Memorandum

Date: December 21, 2011

*Re: Revised Bank Toe Material Sizing For Phase 1 Preliminary Design
Report, Clark Fork River Operable Unit*

Figure 1. Proposed Bank Toe Gradation

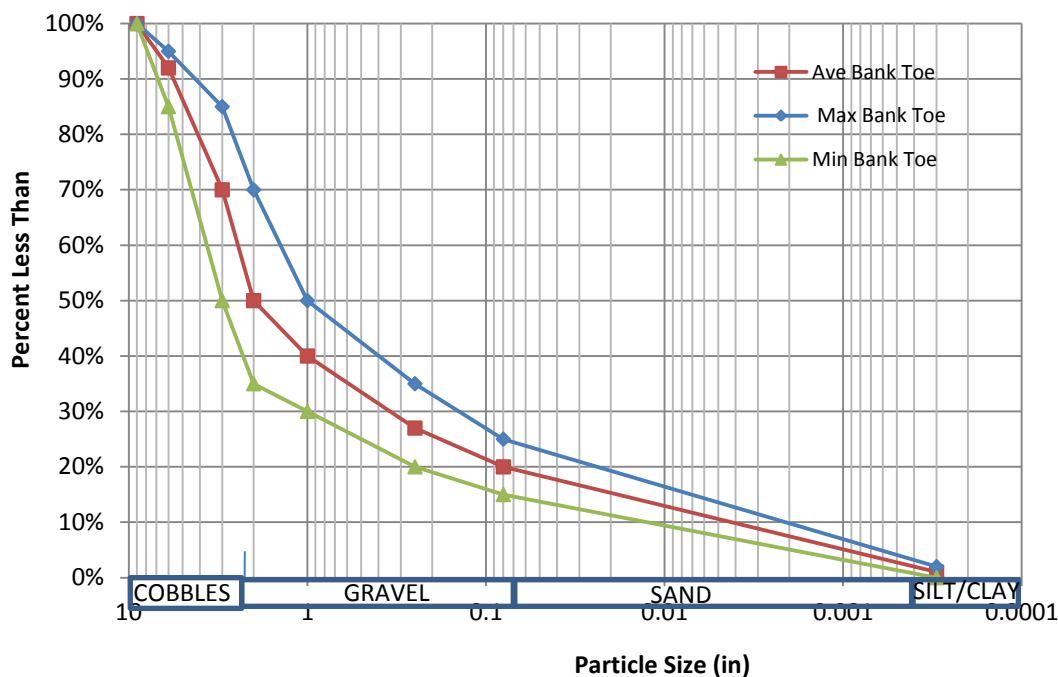
Table 2 shows that the highest corrected shear and largest critical d_{50} size (2.08 in.) occurs on a bend at cross section 42. The second largest shear occurs on a straight section at cross section 36 (1.95 in.). Using a median size of about 2 inches, the bed toe material can be sized to provide the desired degree of bank toe protection; i.e., stable up to the 10-year flow event. Figure 1 shows a proposed gradation for bank toe material for locations where a bank toe needs to be constructed. The average gradation has a d_{50} of 2 inches, a d_{84} of 4.5 inches, and d_{max} of 9 inches.

Please review the proposed bank toe gradation. If it is acceptable to the design team and the agencies, CDM proposes that we implement this bank toe gradation in the next design package for Phase 1. We understand that further adjustment to this and other proposed gradations may need to be made once sources for the alluvial material are designated.
